PECO NUCLEAR

Subject: Limerick Generating Station, Unit 2
Technical Specifications Change Request No. 00-02-2
Changes to Reactor Pressure Vessel Pressure-Temperature Limits and
Request for Exemption from the Requirements of 10 CFR Part 50,
Section 50.60(a)

**TECHNICAL SPECIFICATIONS CHANGE REQUEST
NO. 00-02-2**

MINIMUM REACTOR VESSEL METAL TEMPERATURE VS. REACTOR VESSEL PRESSURE
FIGURE 3.4.6.1-1

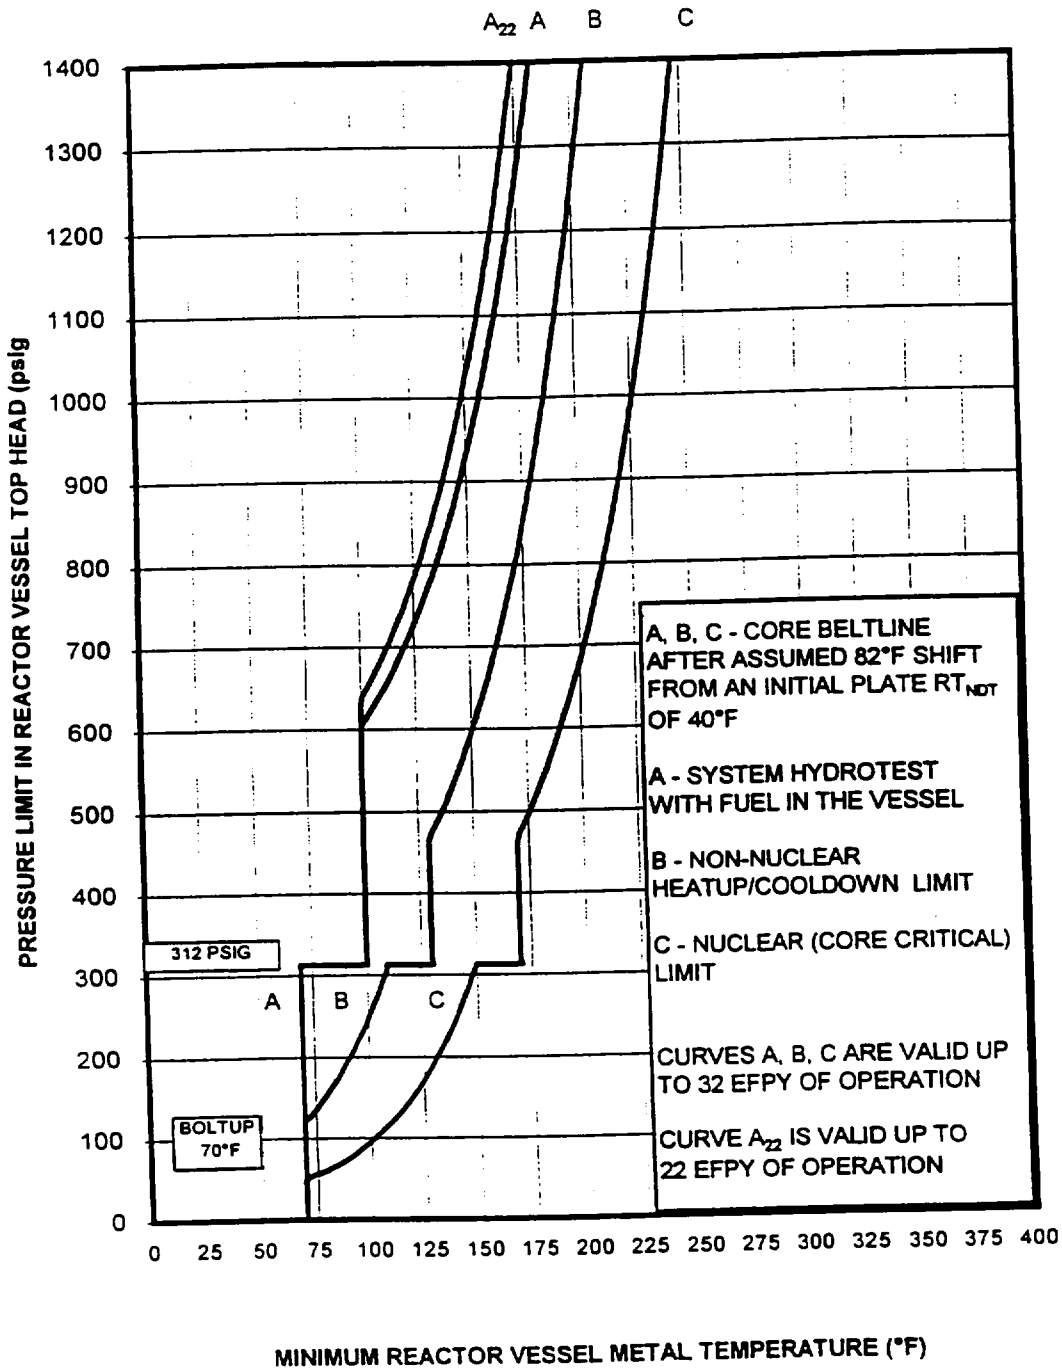
PECO Energy is requesting TS changes which will revise the heatup, cooldown, and inservice test P-T limitations (curves) specified in TS Figure 3.4.6.1-1 for the LGS, Unit 2 RPV to a maximum of 32 EFPY. In addition, text changes are proposed to both Limiting Condition for Operation (LCO) 3.4.6.1 and Surveillance Requirement (SR) 4.4.6.1.1 to delete the reference to the A' curve on TS Figure 3.4.6.1-1 since this curve will not be included in the proposed Figure 3.4.6.1-1. An intermediate hydrotest curve (Curve A₂₂) was also added to TS Figure 3.4.6.1-1, which is valid to 22 EFPY.

- Change Heat B 3416-1 ΔRT_{NDT} from +82°F to +48°F
- Change Weld AB ΔRT_{NDT} from +114°F to +58°F

- Change the bottom head dome heat number from C9306-2 to C9245-2
- Change the bottom head dome RT_{NDT} from +26°F to +22°F
- Change the vessel flange RT_{NDT} from -20°F to +10°F

REVISE AS
SHOWN ON
NEXT PAGE
